REVISED RESPONSE TO REQUEST FOR ADDITIONAL INFORMATION

APR1400 Design Certification

Docket No. 52-046

RAI No.: 255-8285
SRP Section: 03.08.05 - Foundations
Application Section: 03.08.05
Date of RAI Issue: 10/19/2015

Figure 1 Typical Detail for Installation of Waterproofing Membrane

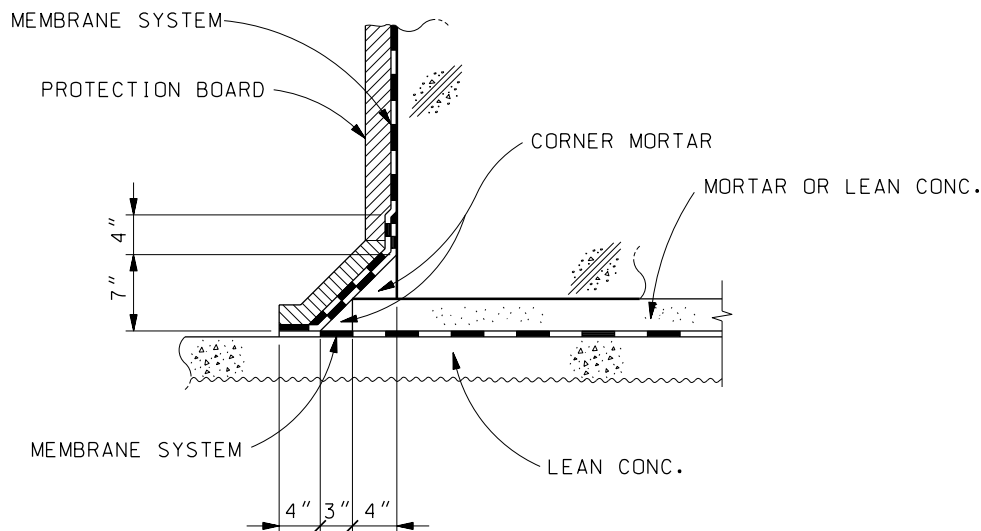
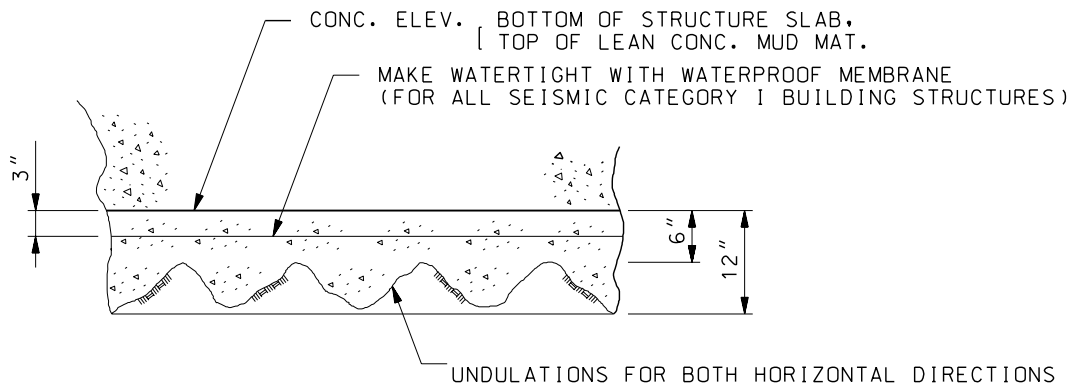
Applicant is requested to describe, whether waterproofing membranes are used in APR1400 design, and if used, provide effects on the shear resistance of the NI common basemat.

Typical detail for installation of the waterproofing membranes is shown in Figure 1. Because the membranes are installed between lower and upper lean concrete beneath the basemat, they affect the shear resistance of the NI common basemat.

The sliding by shear transfer may be considered across the interfaces between dissimilar materials, i.e., foundation concrete on lean concrete, lean concrete and waterproofing membrane, lean concrete and the supporting medium (soil or rock), and within the supporting medium.

The coefficient of friction between the lean concrete and waterproofing membrane is **greater than or equal to** 0.55 as described in COL 3.8(13). This value is compared with the coefficients of friction between other interfaces, and the minimum value among them is used for stability check of the basemat.
